The Commonwealth of Massachusetts
TOWN OF LENOX

Town of Lenox
Commonwealth of Massachusetts
Zoning Board of Appeals
Application for a Special Permit Amendment

Nature of special permit: Mr. and Mrs. Lo received special permits (March 4, 2020, as amended October 8, 2020) for the renovation of their single-family home on 130 Cliffwood Street. The

Revised Carport Location Oct 2022

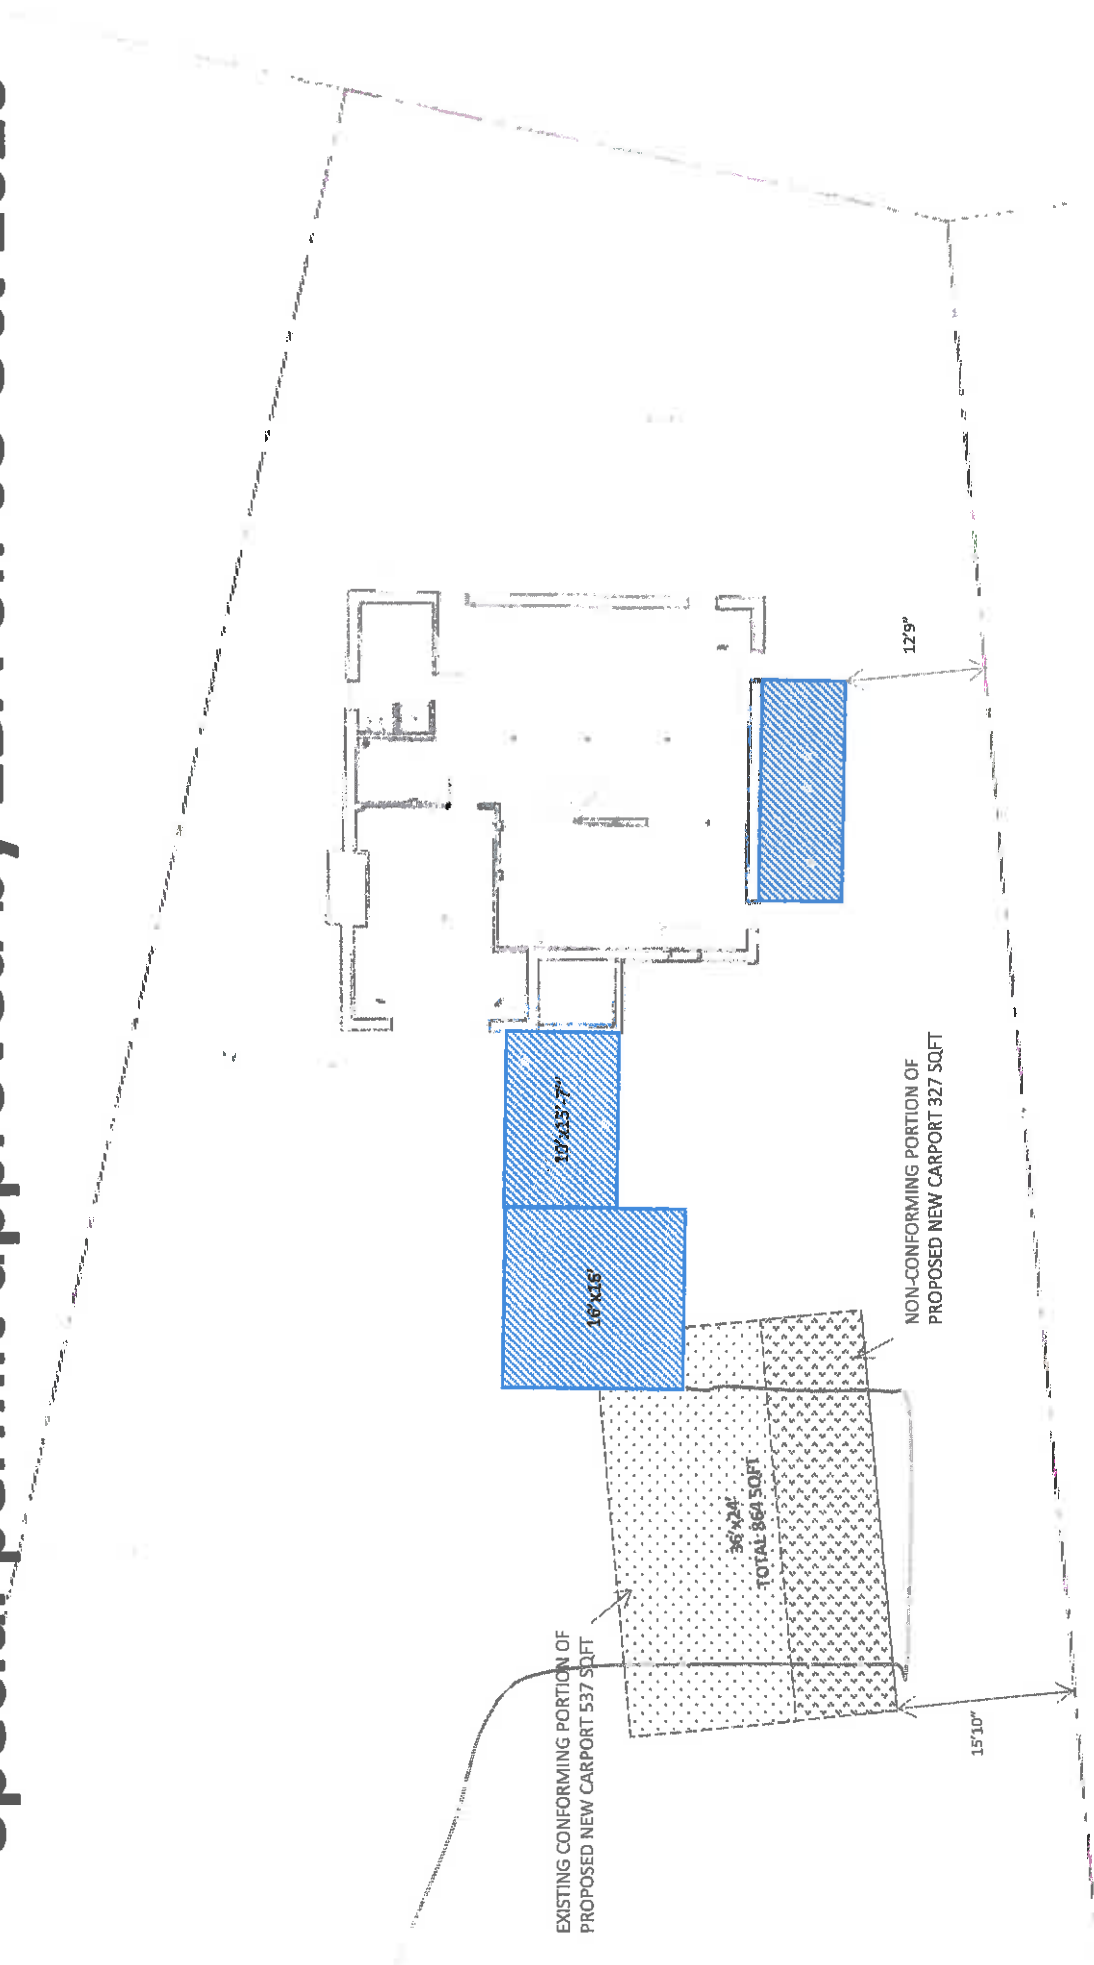
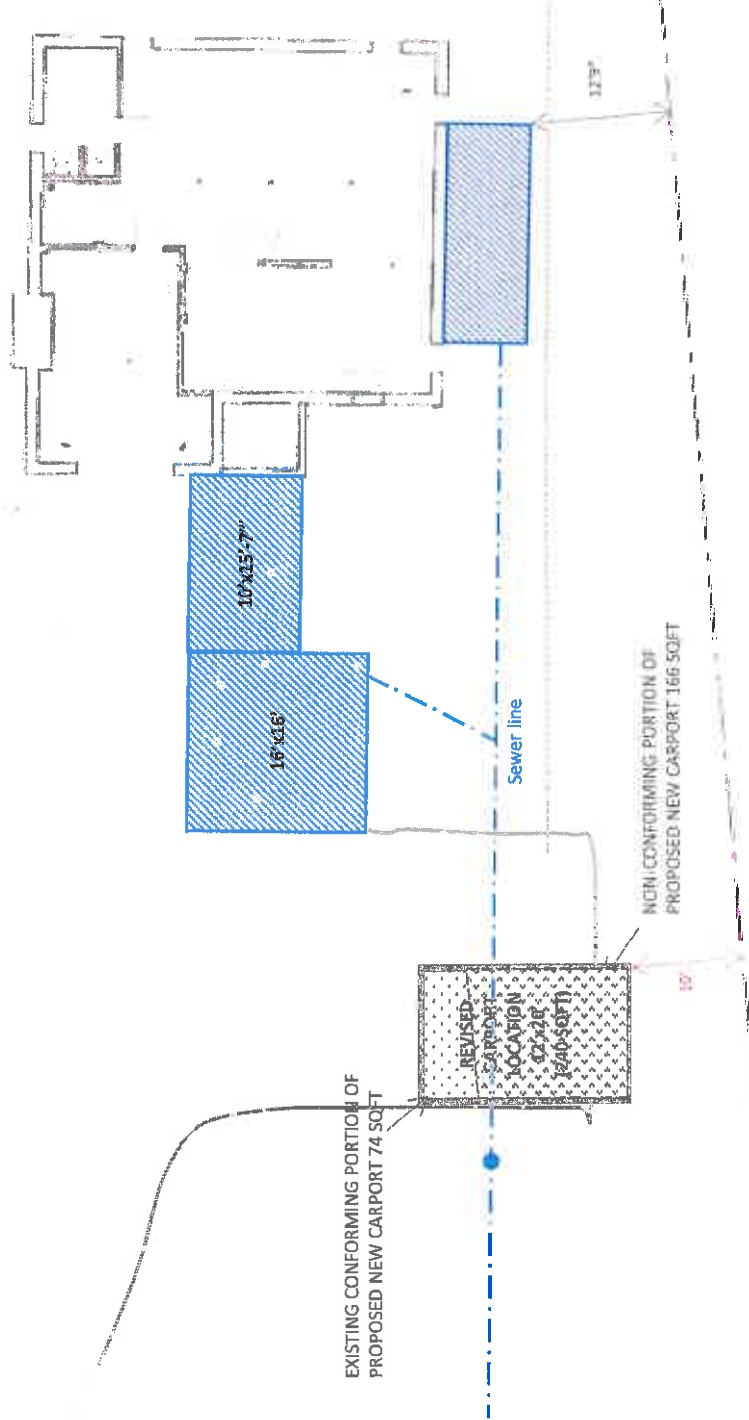
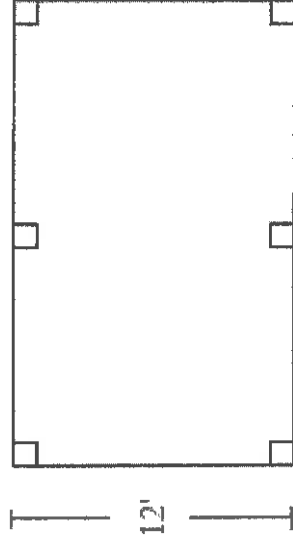
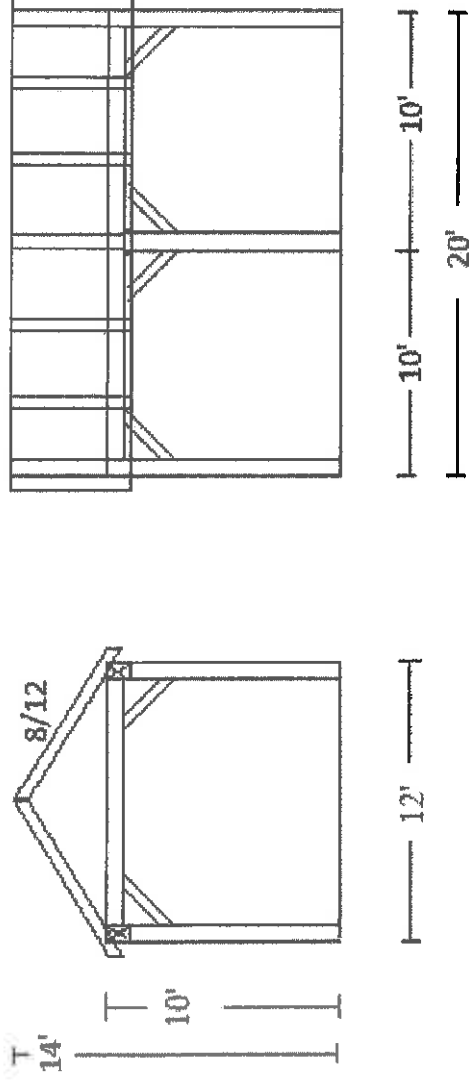
After receipt of the amendment to the Special Permit in October 8, 2020 and in consultation with their contractor. Mr. and Mrs. Lo determined a smaller car port would satisfy their needs. Mr.

and Mrs. Lo redesigned a small car port, but the redesign locates the structure closer to the abutting property line. Changing the design to better accommodate the set back is not viable

because shifting the car port north will place it directly on top of the sewer line.

The revised plans attached hereto shows the car port as previously approved. It measures 36' x 25' feet and at its closest point is 15' 10" from the southerly property line.

The redesigned car port is 12' x 20' and sits 10' feet from the southern property line.

EXISTING CONFORMING PORTION OF
PROPOSED NEW CARPORT 74 SQFT

REVISED
CARPORT
LOCATION
22'x28'
(616 SQFT)

NON-CONFORMING PORTION OF
PROPOSED NEW CARPORT 166 SQFT

Proposed Carport Construction

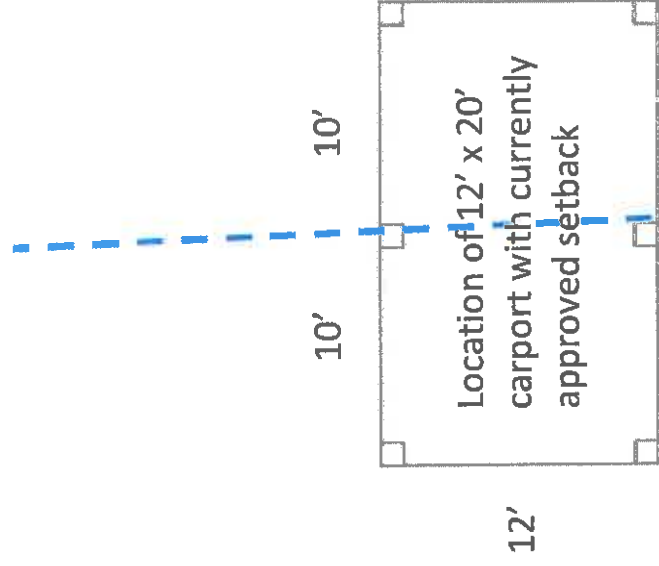
- 12' x 20' footprint
- 10'-0" plate height
- 10½" roof overhangs / Gable & Eave / 8:12 roof pitch
- Roof structure: traditional timber rafters @ 4' intervals
- Wall structure: open air
